2x2 Submersible Pump Installation

2x2 Installation Meeting

August 21, 2023

Photo Gallery

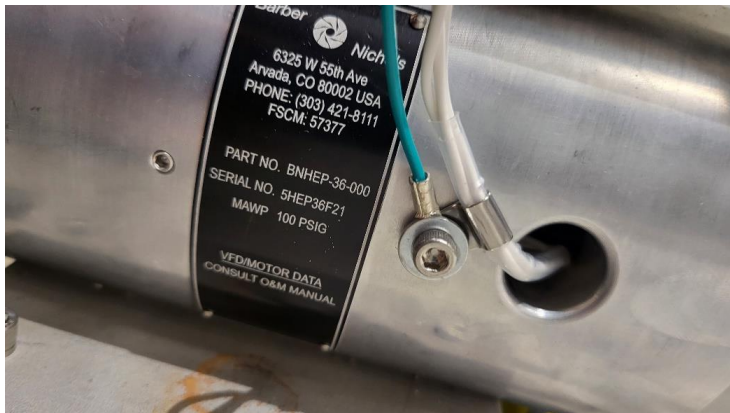
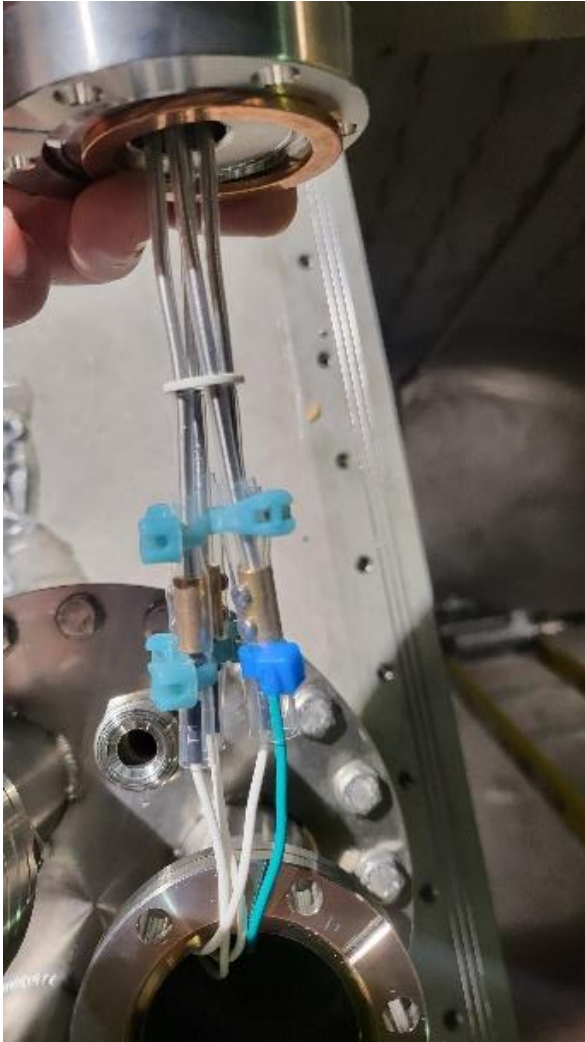
- An 'As Built' review was conducted to compare the documentation with the installation and to confirm safety considerations and 'best engineering practices' were followed.
- Some issues were identified, requiring mitigations, so the opportunity was taken to perform the requested 'bump' test.
- The purpose of a 'bump' test is twofold:
 - Does the pump work?
 - Is the rotation correct per the phase wiring schematic?
- To conduct the requested 'bump' test, the pump was removed from the 2x2 cryostat and tested at PAB with the AC power supply planned for use in the experiment.

- All piping, used as wire conduit, cleaned per standard procedures for use in a LAr cryostat.
- Flange connector, cold side connections, augmented with Teflon heat shrink to prevent phase → phase and phase → ground shorts.
- Organized wiring in junction box for ease of disconnection for maintenance.
- Stabilized ‘cantilever’ pipe.

'Bump' test

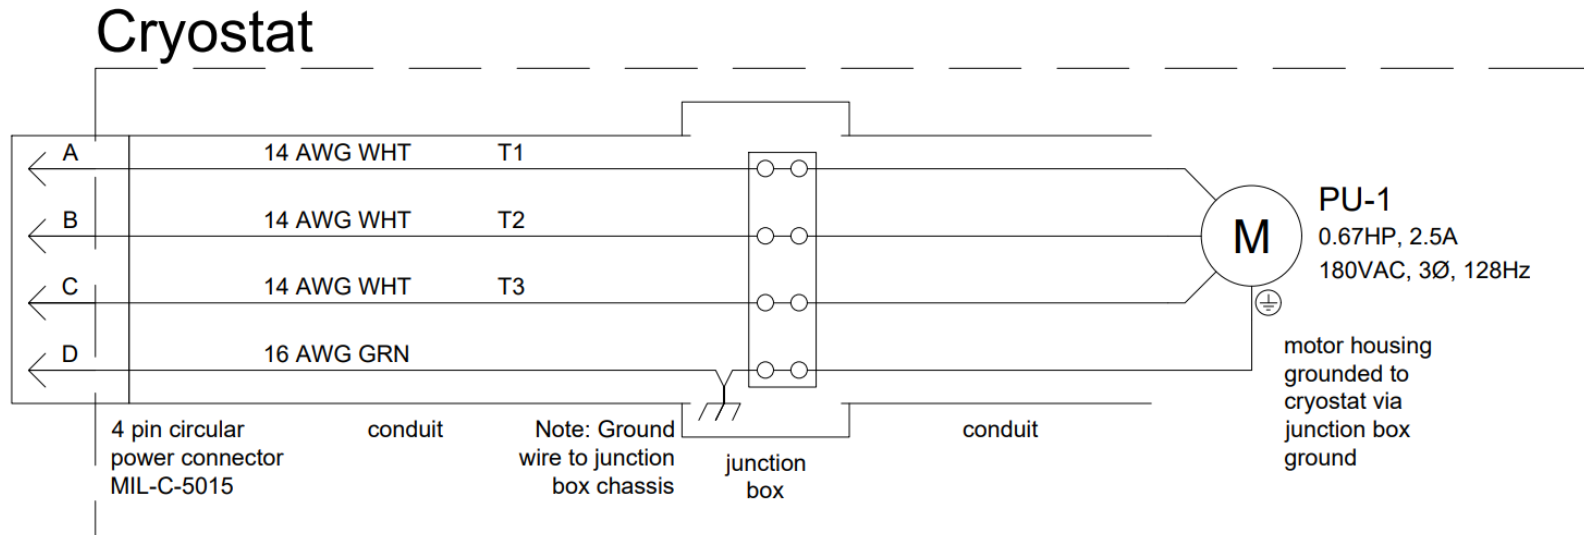
- Pump works!
- Rotation was wrong direction.
- Will swap T1 (L1) and T2 (L2) at connection to power supply.
- Updating schematic to include wire labeling and barrier strip.
